Docket Item # 3 BAR CASE # 2008-0175

BAR Meeting November 19, 2008

ISSUE:	Concept Approval for Addition/Alterations
APPLICANT:	Church of God and Saints of Christ, Sixteenth Tabernacle
LOCATION:	634 N. Patrick Street
ZONE:	RB/Residential

Figure 2: Current site plan for November 19 hearing.

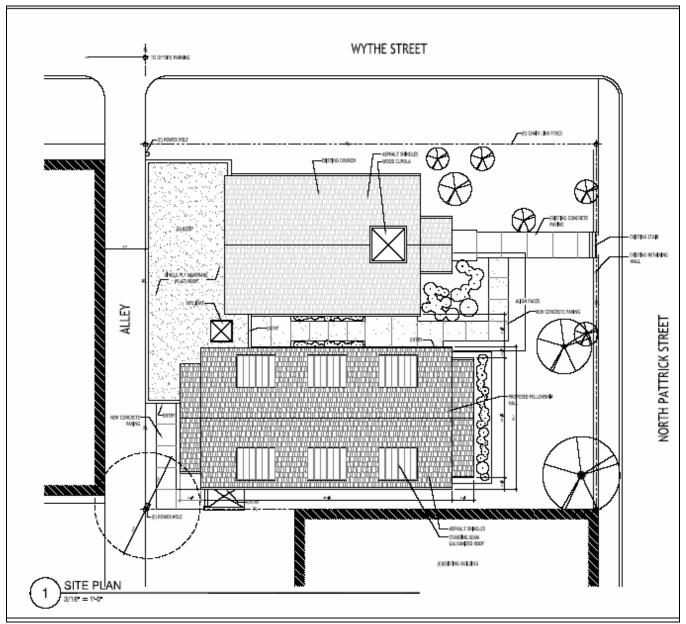
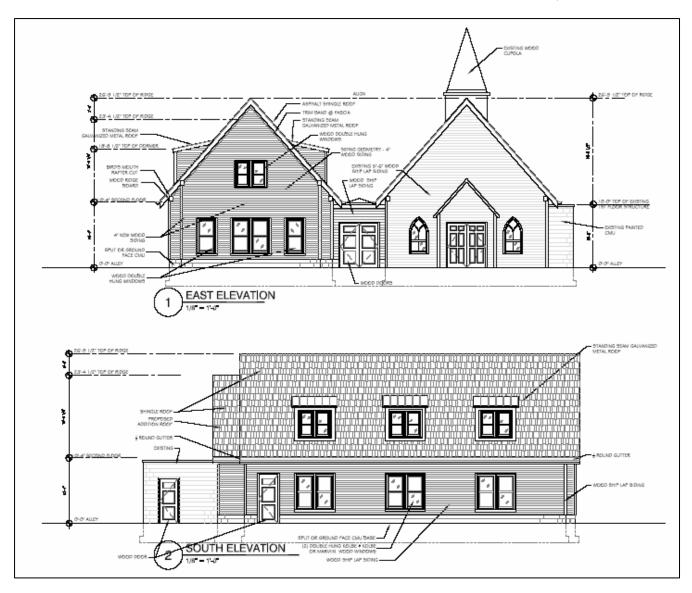
<u>Update:</u> Since the October 22, 2008, Board meeting, the applicant has made revisions to the concept design for the new addition to the Church of God and Saints of Christ, in response to the comments of the Board. The primary change in the design of the addition is pulling the addition 4' towards North Patrick Street, making the addition project approximately 8' forward from the vestibule of the historic church.

The *Design Guidelines* state: "As a general rule, the Boards favor contextual background buildings which allow historic structures to maintain the primary visual importance." As discussed in the prior Staff report for the concept, Staff had concerns that the new addition could become the prominent element on the site, with the historic church becoming the back ground building, rather than the focal point. For the most part, the Board has disagreed with the Staff analysis on this issue, and found that the 4' projection of the addition beyond the vestibule of the historic church appropriate and did not detract from the historic church's dominance on the site. The Board also encouraged the applicant to explore making the projection even more pronounce towards North Patrick Street. The current submittal has the addition projecting 8' beyond the vestibule of the historic church towards North Patrick Street. While Staff maintains reservations about this approach, the applicant has responded to the Board's comments in the current proposal.

Therefore, because the applicant has responded to the comments and recommendation of the Board, Staff recommends approval of the Concept for the construction of the new addition, because it is appropriate in terms of scale, mass, height, and general architectural expression, and meets the Design Guidelines.

Figure 4: Current proposal for east and south elevations for November 19 hearing.

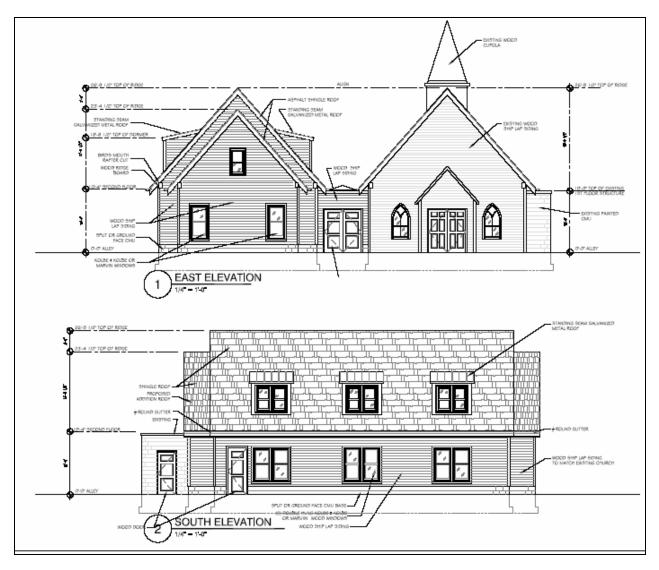
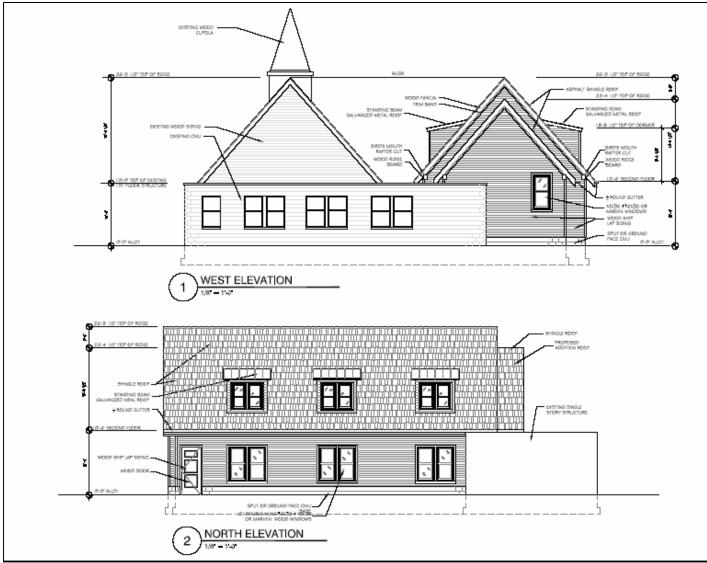
In terms of the changes to the window configuration on the east façade of the addition, Staff supports this change, and believes that it provides a more successful and appropriate solid to void ratio for this elevation. Staff also supports the change of expanding the roof form over the east

elevation, while retaining the recessed elements at the corner. Staff does have some concerns about the skylight now being shown on the connecting element, but that should be addressed under the Certificate of Appropriateness discussion for materials and final design details.
